SYDNEY GRAMMAR SCHOOL

ADDENDUM TO THE VISUAL IMPACT ASSESSMENT

SYDNEY GRAMMAR SCHOOL WEIGALL SPORTS COMPLEX

(SSD-10421) RESPONSE TO SUBMISSIONS

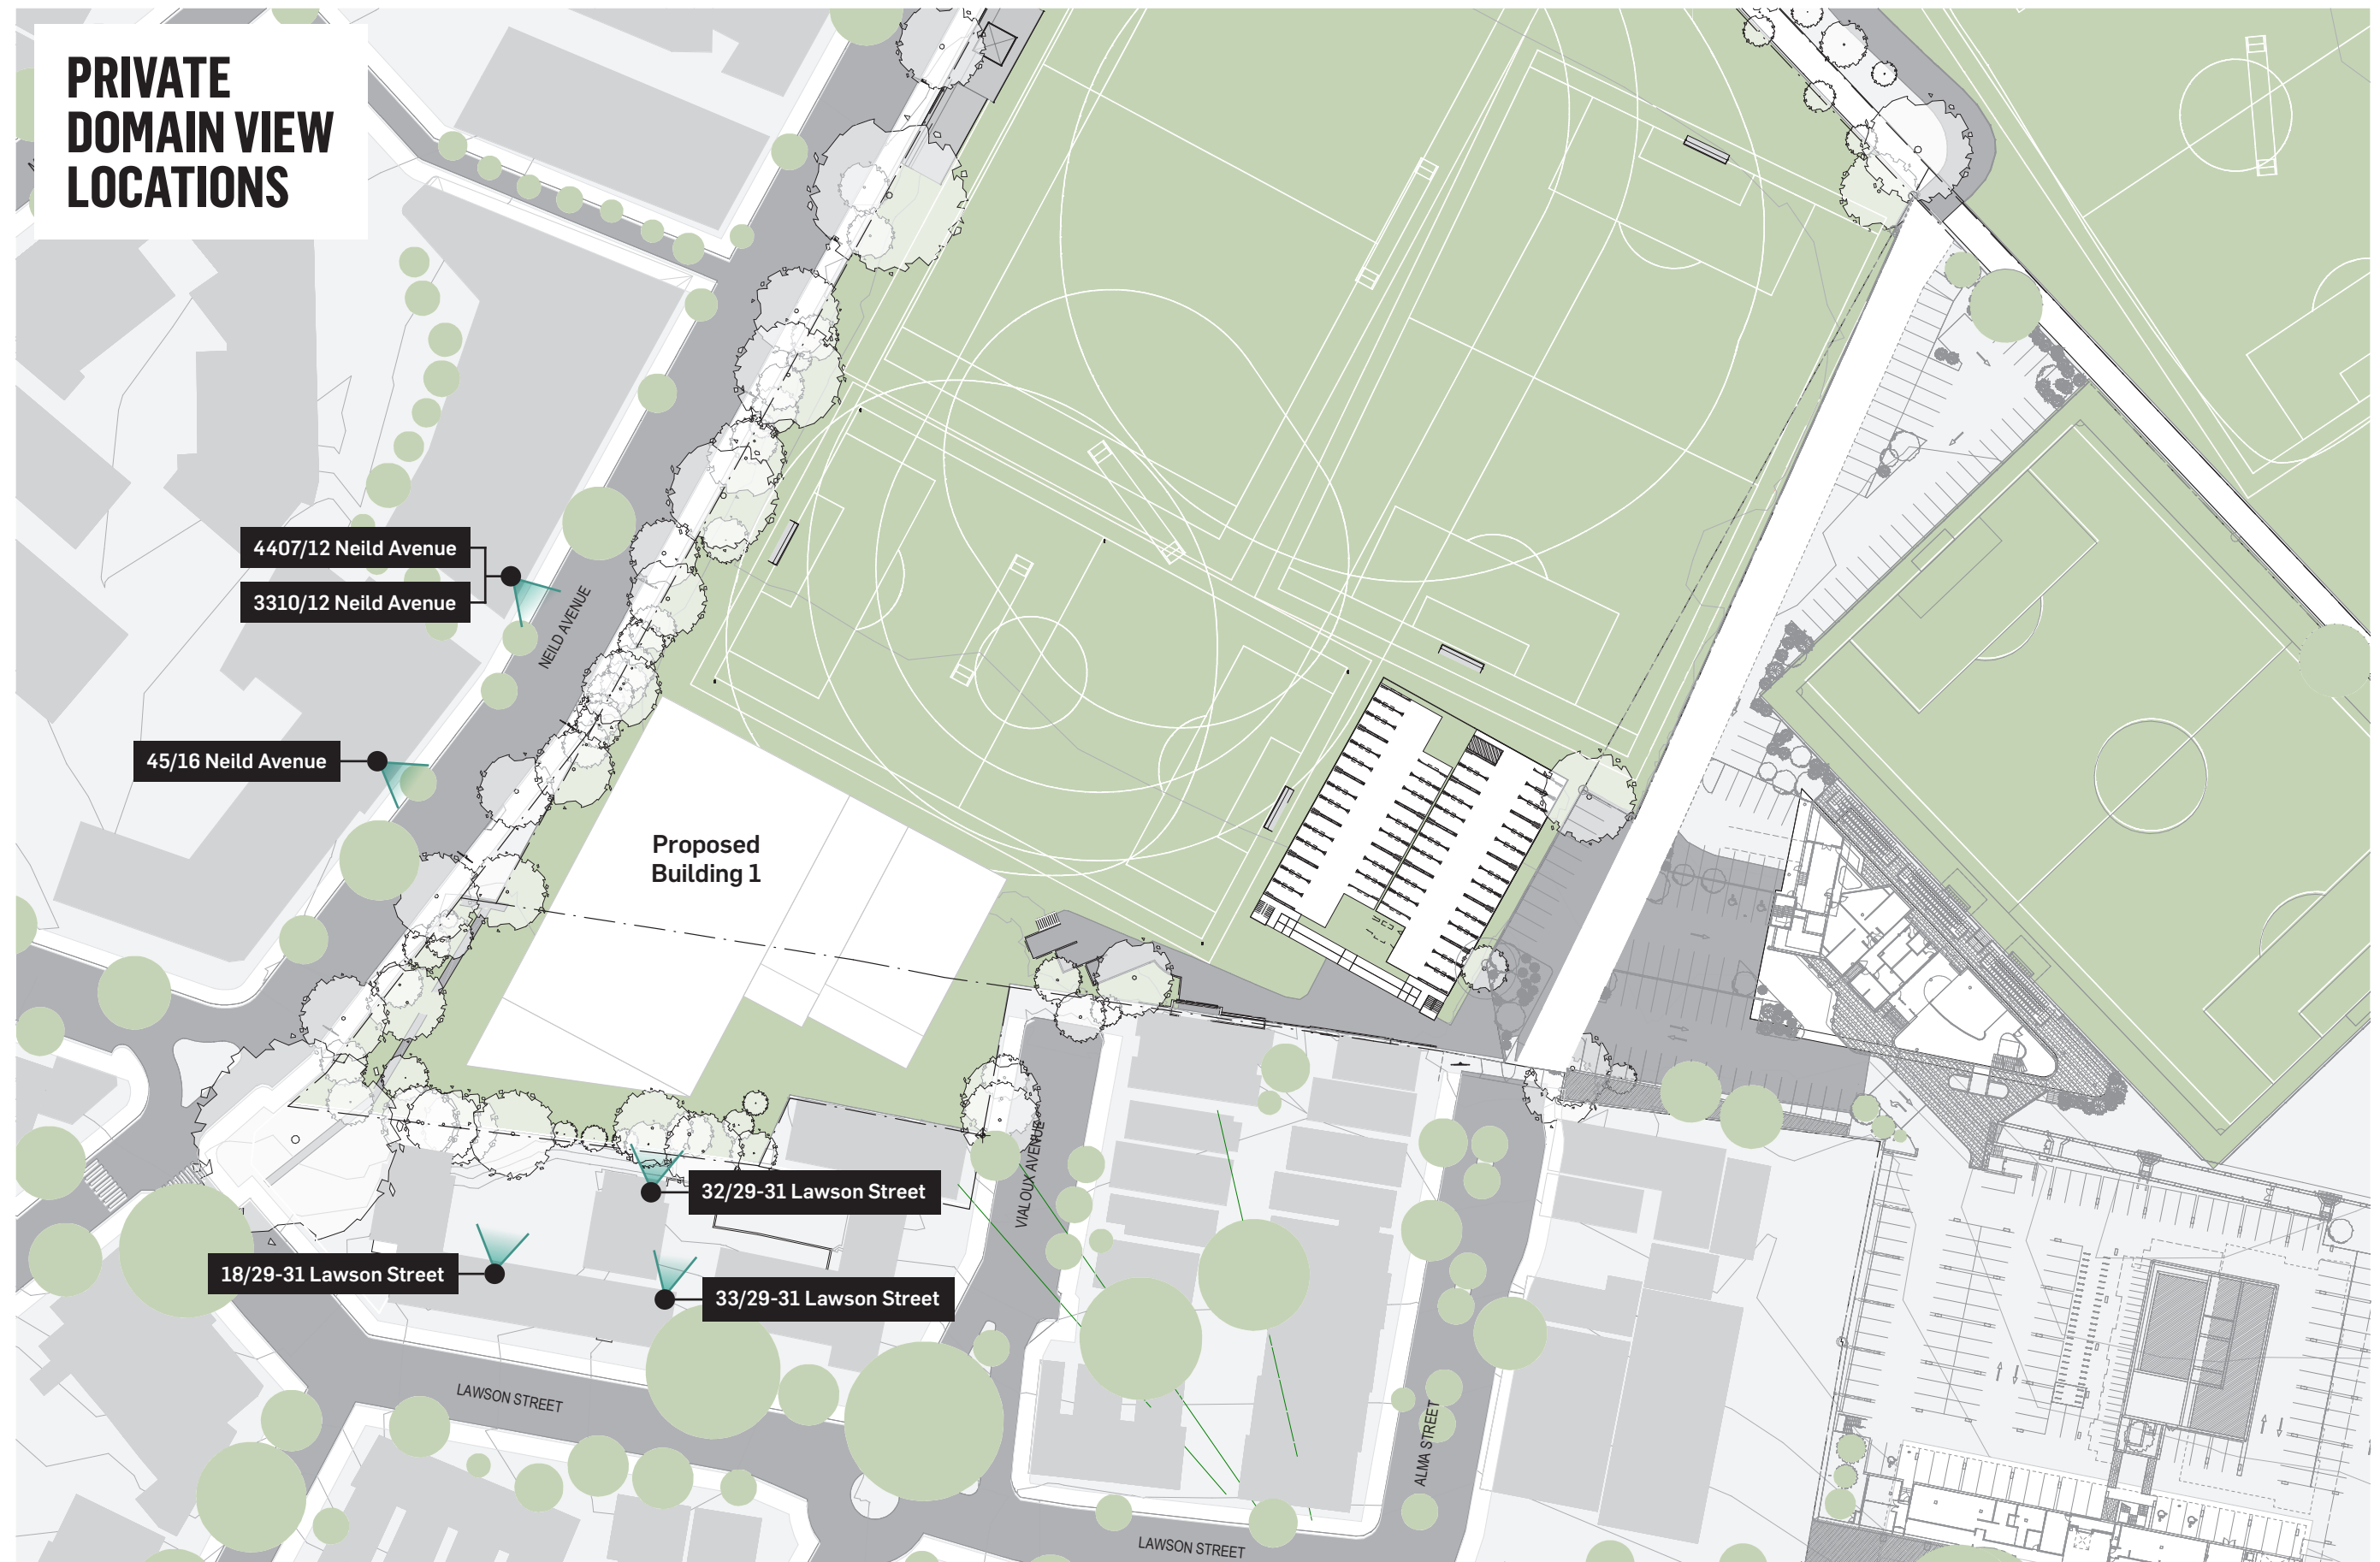
Council’s Urban Design Officer is of the opinion that existing landscaping would not screen the entire habitable areas at 25-27 and 29-31 Lawson Ave (refer Figure 1). Therefore, the proposed bulk and scale would affect additional habitable areas on these two buildings. As such, it is recommended that the proposed bulk and scale of the Building 1 is redesigned with more consideration to maintaining view sharing with the affected sites.

The proposed development does not create any significant visual effects in any public domain views mapped or identified in the DCP r LEP. Please refer to the VIA for further information.
